Re: Harrison Recreation and Community Center – Phase 2

BULLETIN # 0 4

PROJECT: Harrison Recreation & Community Center – PHASE 2
Harrison, NY

RE: Additional Work from Phase 1 to Phase 2 Contractor

SSK-1 SLAB HAUNCH DETAIL
(REV.)

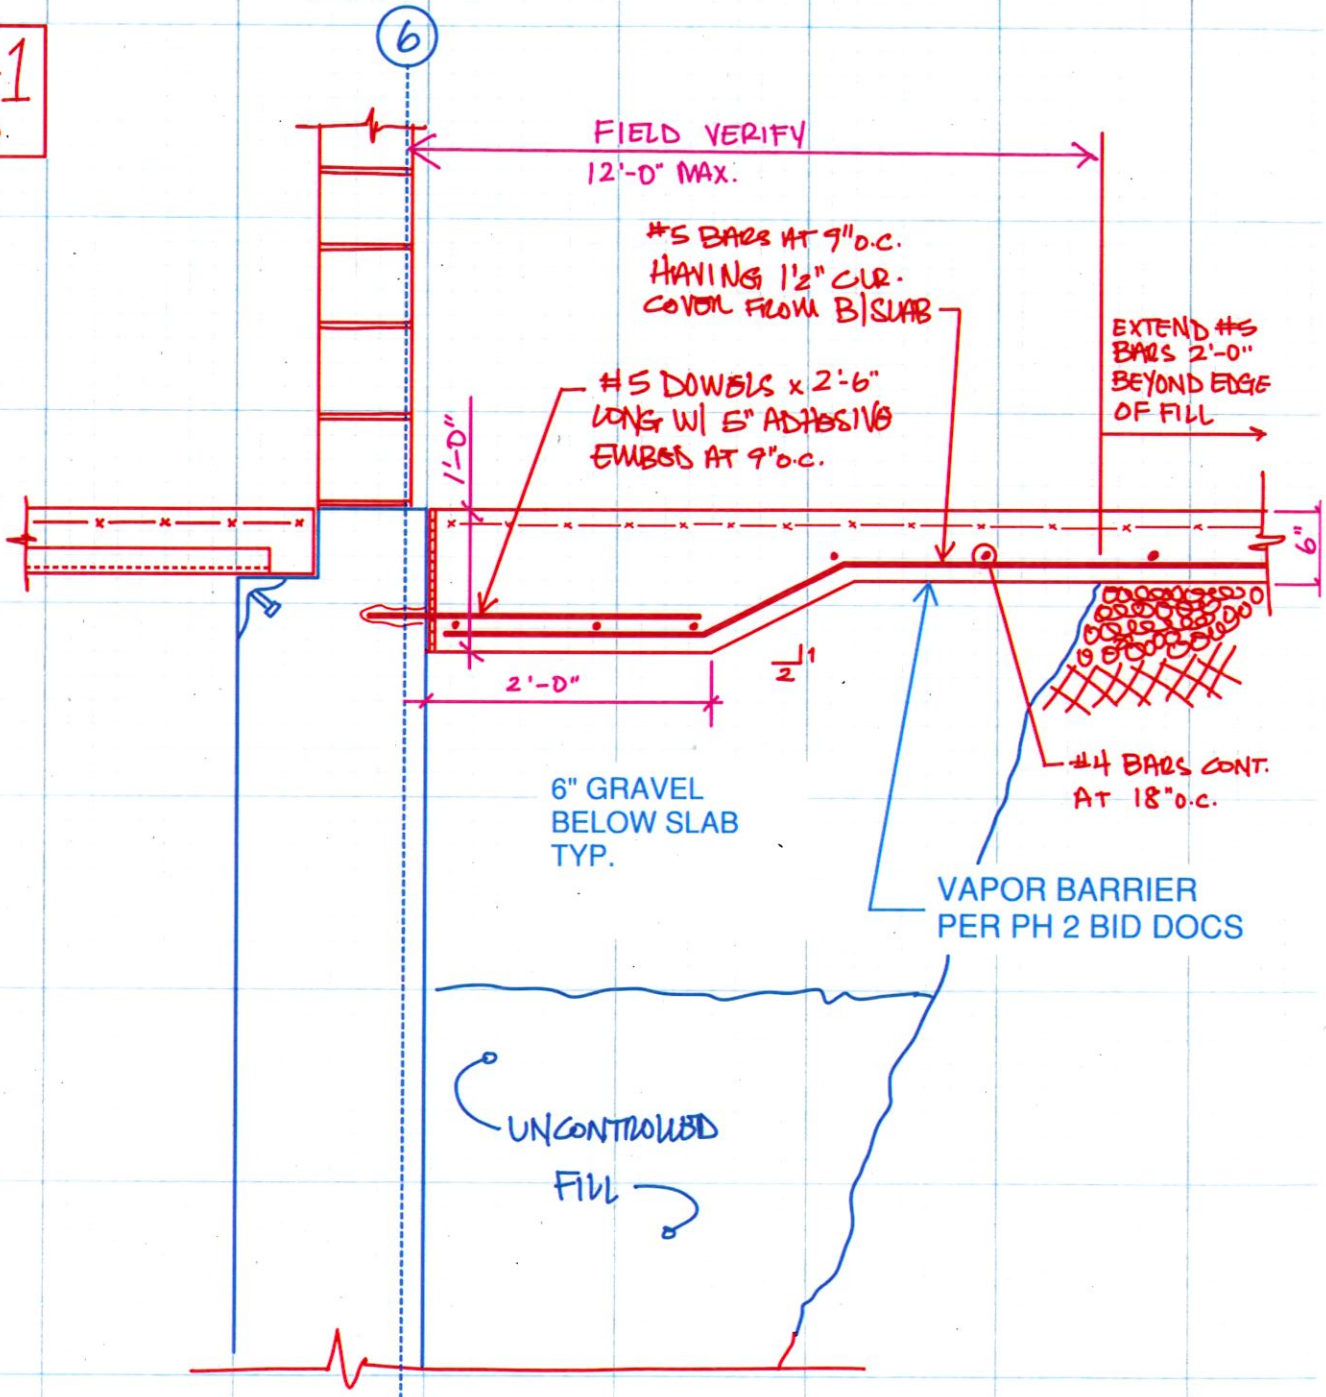
Phase 2 Contractor to provide a haunched slab on the north side of the 6 line retaining wall as shown on SSK-1 attached. (The vapor barrier as noted in the Skylands report is included in the Phase 2 Bid Docs.)

NOTE: DETAIL WILL TURN AND CONTINUE ALONG GRID LINES A AND C UNTIL RETAINING WALL FTG. STEPS UP AND TRANSITIONS TO FROST WALL FTG.
